ADDENDUM No. 2

Project	T.A. Blakelock H.S. Renovations - Phase 1	Project No.	2215A
Location	1160 Rebecca Street, Oakville, Ontario	Date of Issue	2023 03 30
Owner	Halton District School Board	File	2215/7.1.3

This Addendum forms part of the Contract Documents and amends the original Drawings and Specifications, dated 2023 03 16, as noted below.

4 SECTION DETAIL AT SKYLIGHT IN S109
 A500 1:10

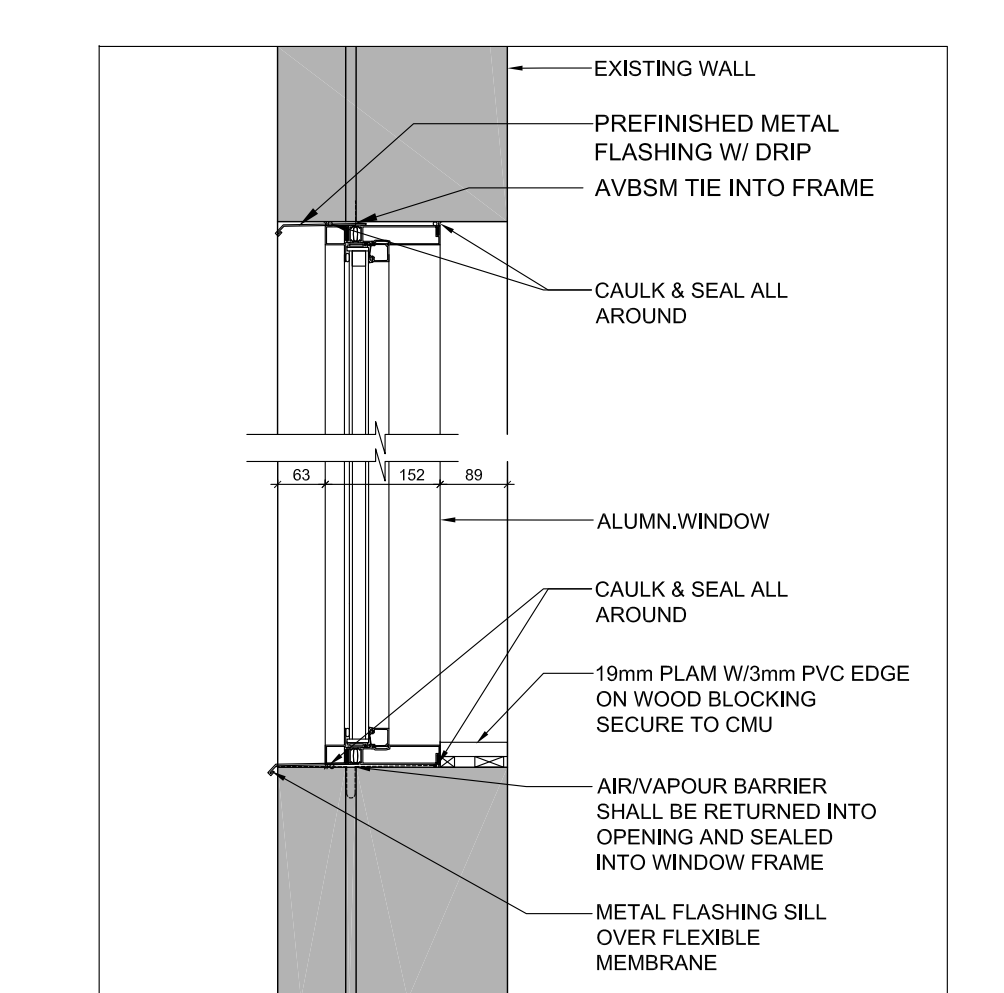
Q4: Demo drawings are calling for the removal of the drywall above the lockers in corridor C001 along with associated metal framing, question being does the existing ceiling run from wall to wall or was the bulkheads installed before the t bar ceilings and then the framing would run to the deck? If the framing is required to go to the deck then most of the t bar in that corridor would need to be removed.

Will there be a section through the bulkheads in the library?

A4: Removal of drywall bulkhead above lockers are by SC02 DEMOLITION & ABATEMENT. Refer to Drawing A500 for details on skylight and related bulkhead in the Learning Commons.

REVISED LOCATIONS OF WORK AREAS

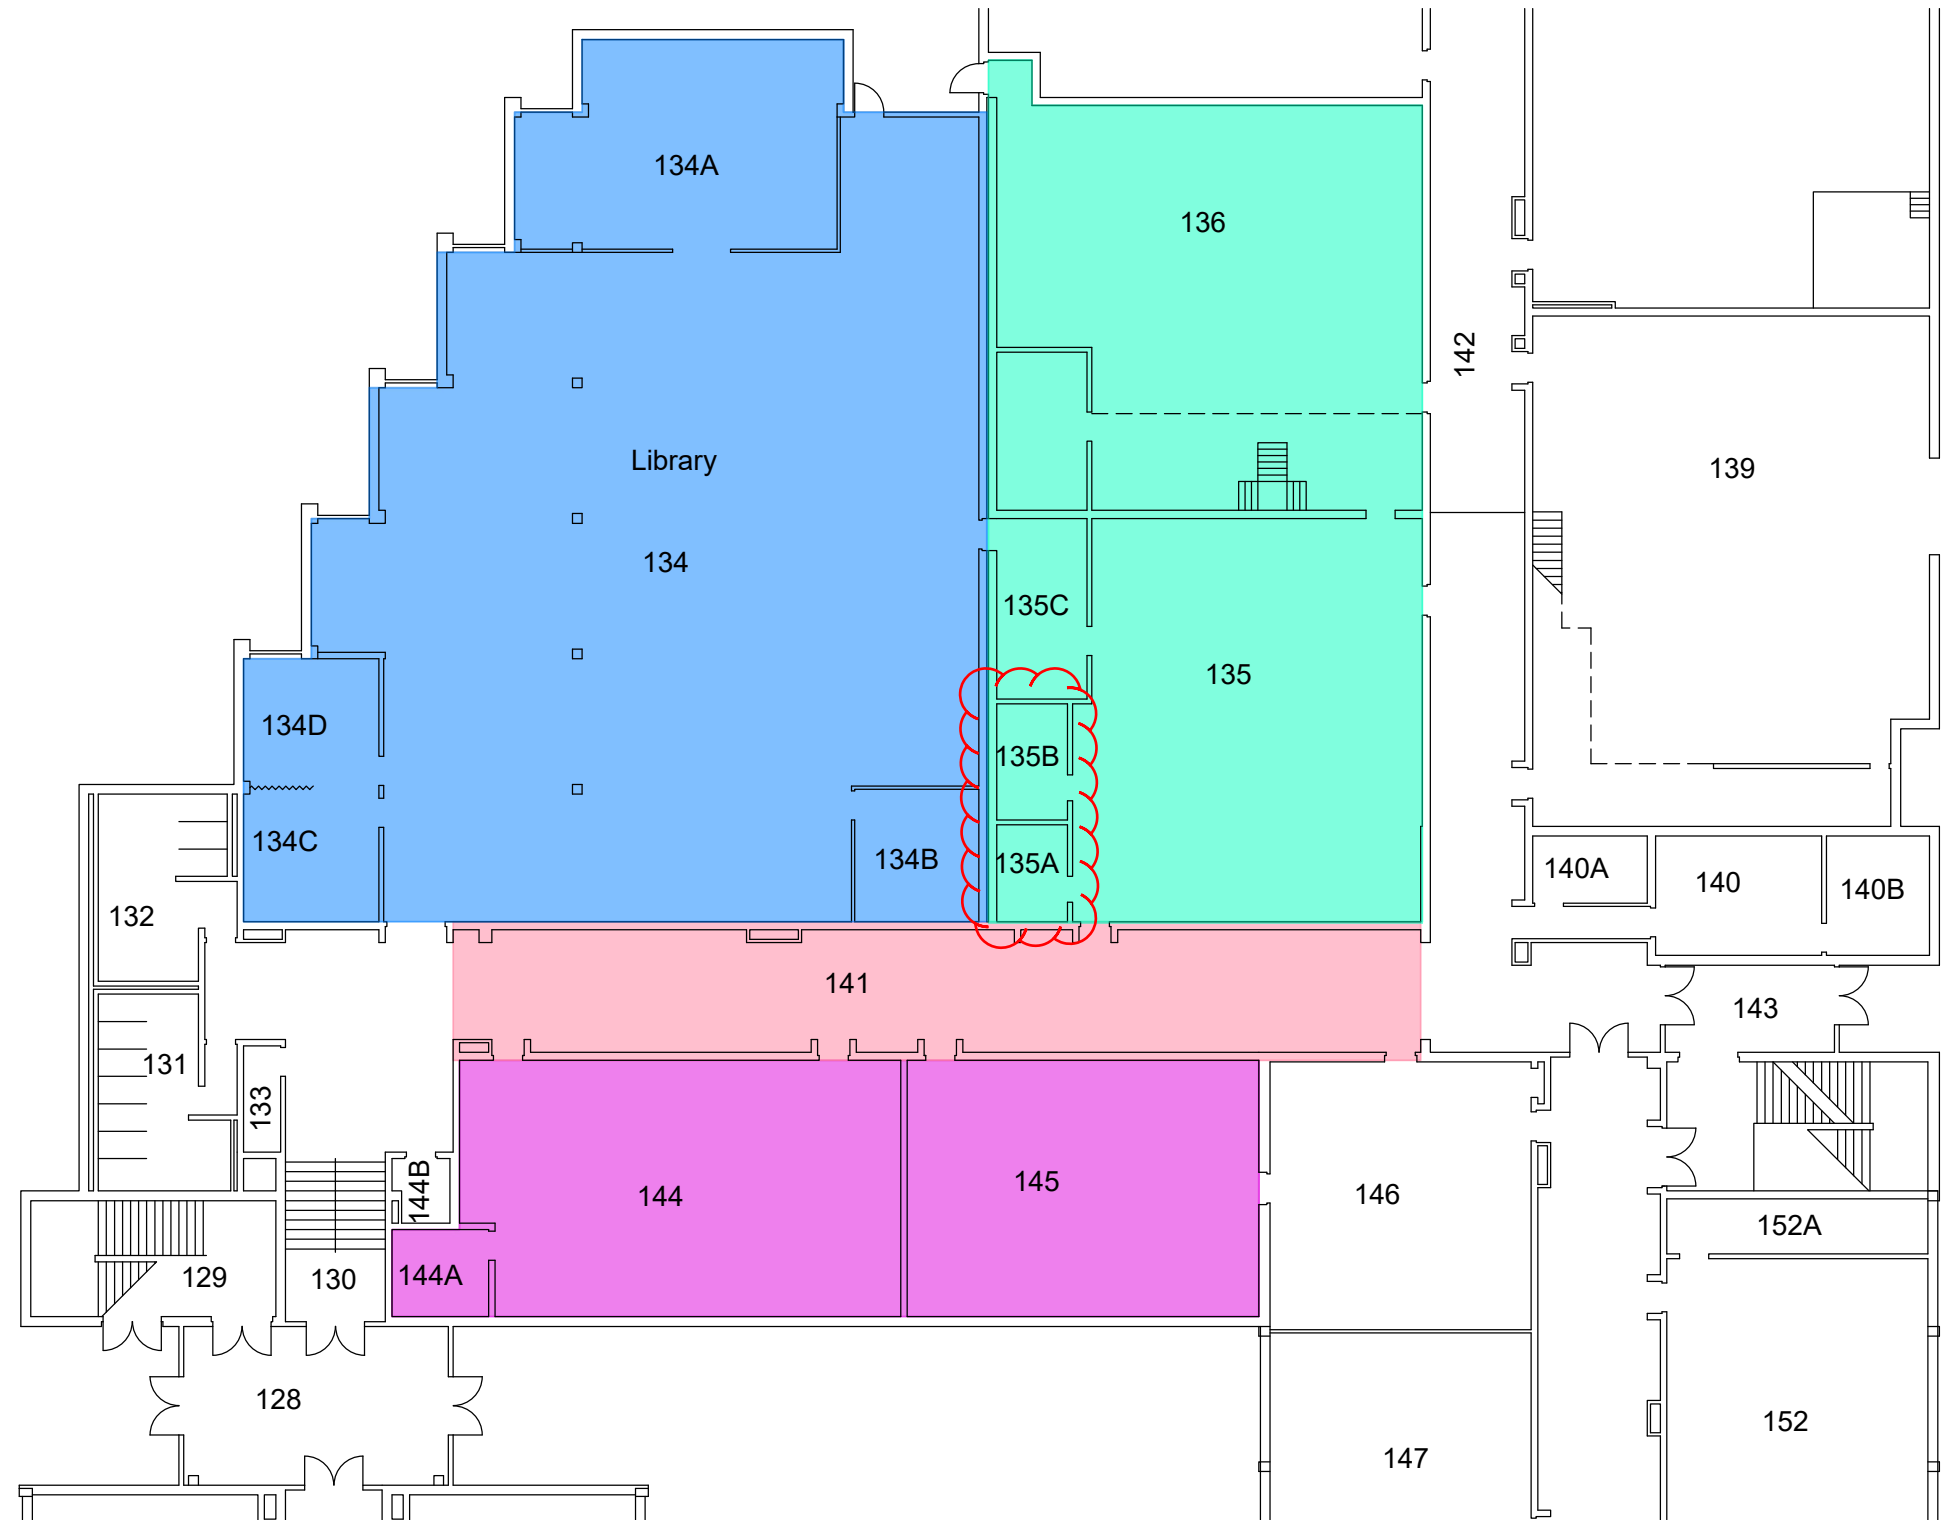
Delete Section 1.2.7 and replace with the following:

.7 Work Area 1 – Rooms 135, 135A, 135B, 135C and 136

- .1 Prepare the areas as indicated above and on the attached floor plans for Type 2 Enclosure and glovebag asbestos removal operations.
- .2 Supply and install scaffolding, in accordance with all applicable regulations, in order to provide sufficient and safe access to the work areas.

- .3 Remove and dispose the following as clean demolition waste:
 - .1 All baseboards in areas where asbestos-containing vinyl floor tiles and walls with gypsum board applications are specified for removal.

- .2 Carpeting in Room 135C.
- .4 Remove and dispose the following as asbestos waste:
 - .1 Entire ceiling assembly including but not limited to 12" x 12" asbestos-containing acoustic ceiling tiles, gypsum board substrate materials, underlying materials, light fixtures and ceiling support systems in Room 135C. Gypsum board, light fixtures and ceiling support systems may be disposed as clean demolition waste provided, they are thoroughly cleaned of all dust and debris.

- .2 All gypsum board and associated asbestos-containing joint compounds and framing materials on walls in Room 135B and on partition walls in Room 136. Framing materials may be disposed as clean demolition waste provided, they are thoroughly cleaned of all dust and debris.

- .3 All asbestos-containing vinyl floor tiles in Rooms 135, 135A, 135B, 135C and 136.
- .5 Using glovebags inside the enclosure work areas, remove and dispose as asbestos waste, all asbestos-containing thermal insulation applied to pipe fittings. For costing purposes allow for the removal of thermal insulation from a total of fifteen (15) pipe fittings.

Delete Drawing 30167489-1 – Asbestos Abatement Specifications, Locations of Work Areas, Thomas A. Blakelock High School, 1160 Rebecca Street, Oakville, Ontario, First Floor Plan dated February 2023 and replace with revised attached drawing:

Drawing 30167489-1 – Asbestos Abatement Specifications, Revised Locations of Work Areas, Thomas A. Blakelock High School, 1160 Rebecca Street, Oakville, Ontario, First Floor Plan dated February 2023

Changes to drawing are highlighted on the drawing in a cloud.

REVISED LOCATIONS OF ASBESTOS CONTAINING MATERIALS AND STUDY AREAS

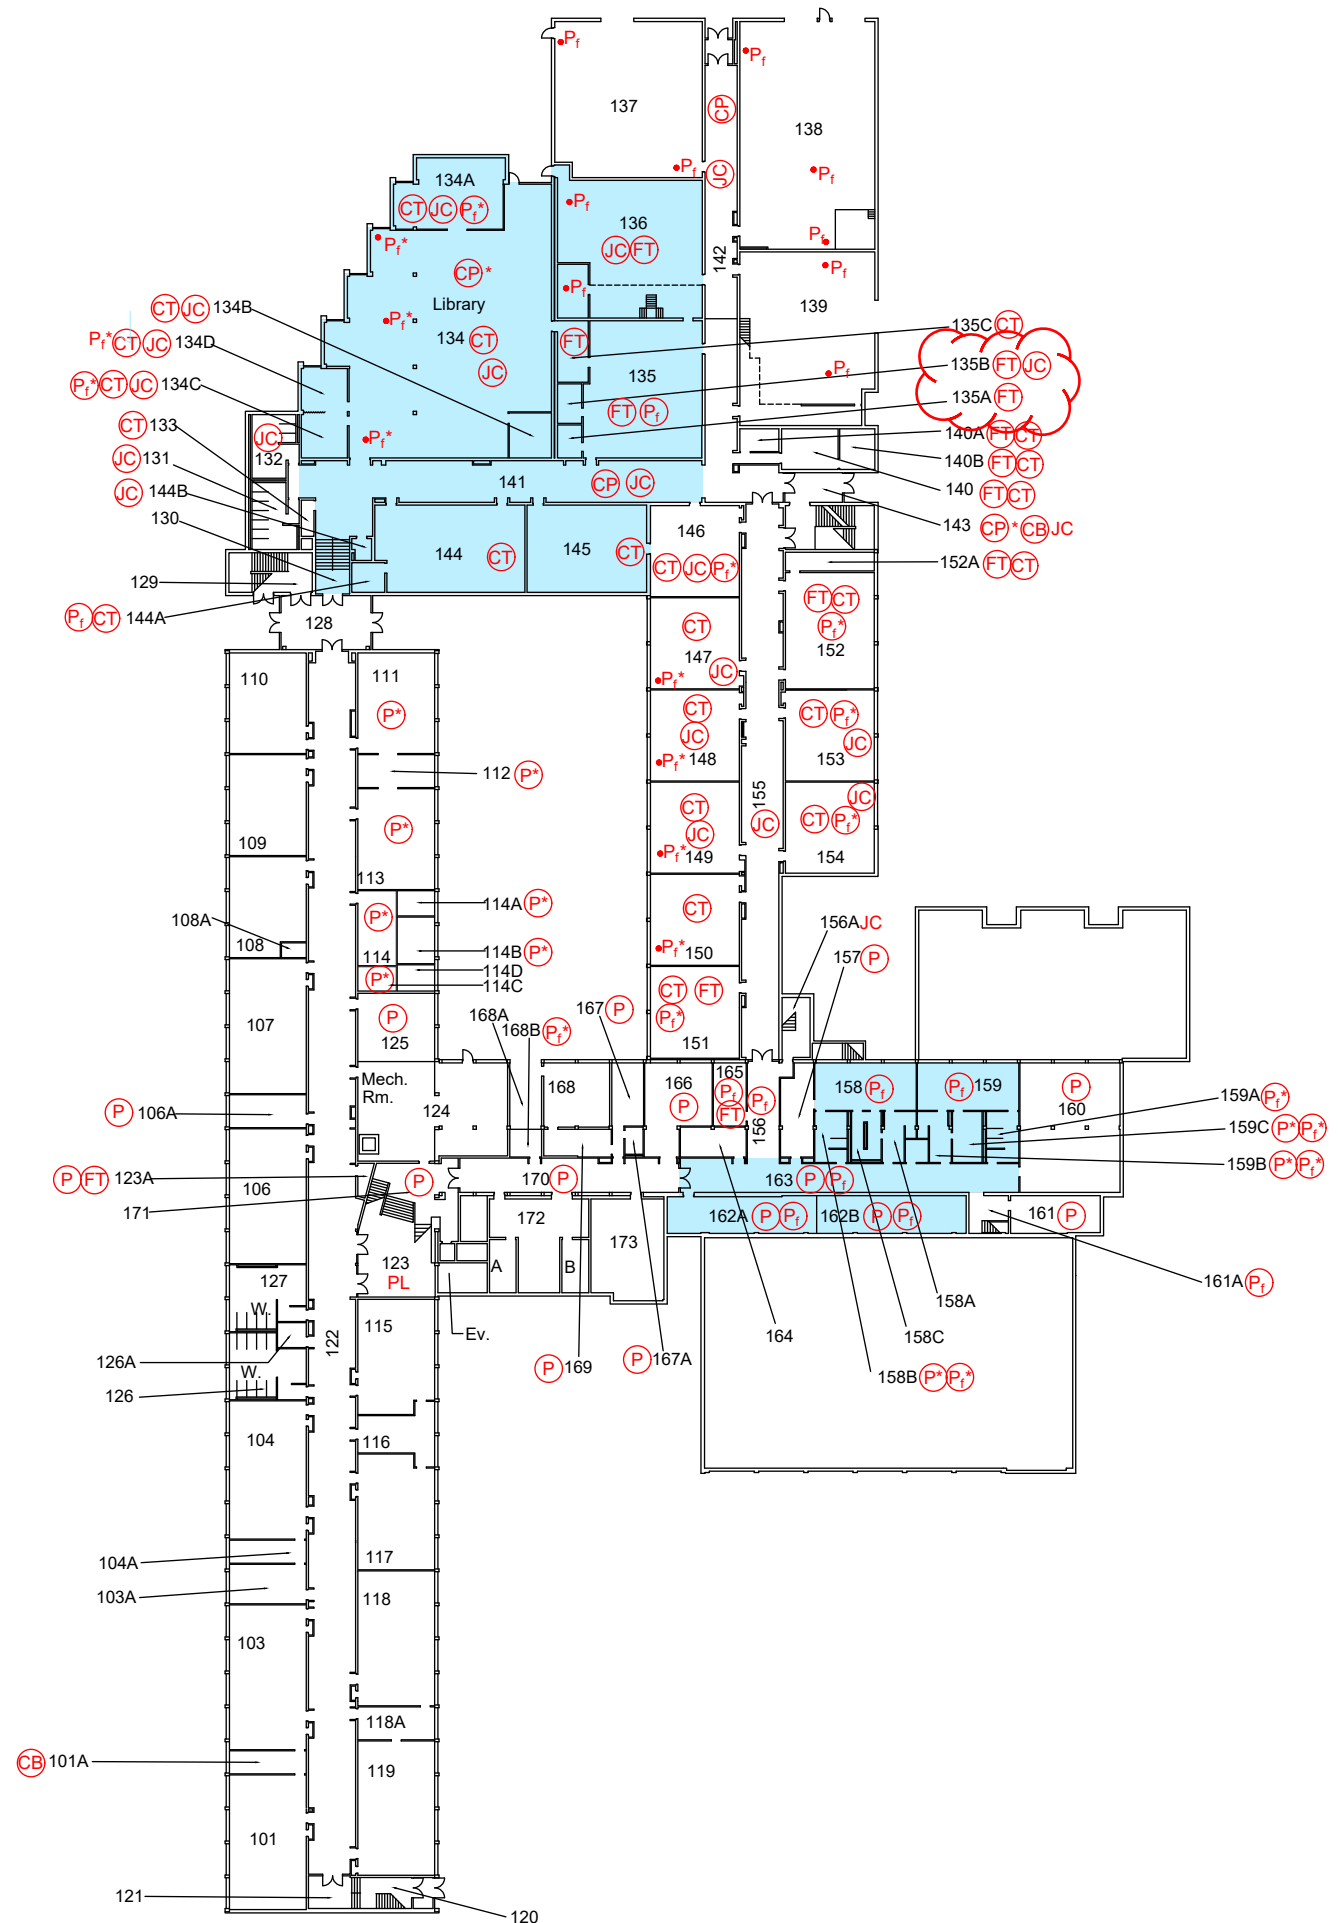
Delete bullets:

- 12"x12" vinyl floor tiles in Rooms 135, 135B and 136;
- Gypsum board with associated asbestos-containing joint compound applied to walls in Rooms 134, 134A, 134B, 134C, 134D and 136;

And replace with the following bullets:

- 12"x12" vinyl floor tiles in Rooms 135, 135A, 135B and 136;
- Gypsum board with associated asbestos-containing joint compound applied to walls in Rooms 134, 134A, 134B, 134C, 134D, 135B and 136;

Replace the following with revised attached drawing dated February 2023:

30167489-1 – Pre-Renovation Designated Substances and Hazardous Materials Survey, Revised Locations of Asbestos-Containing Materials and Study Area, Thomas A. Blakelock High School, 1160 Rebecca Street, Oakville, Ontario, First Floor Plan

Changes to drawings are highlighted on the drawings in a cloud.
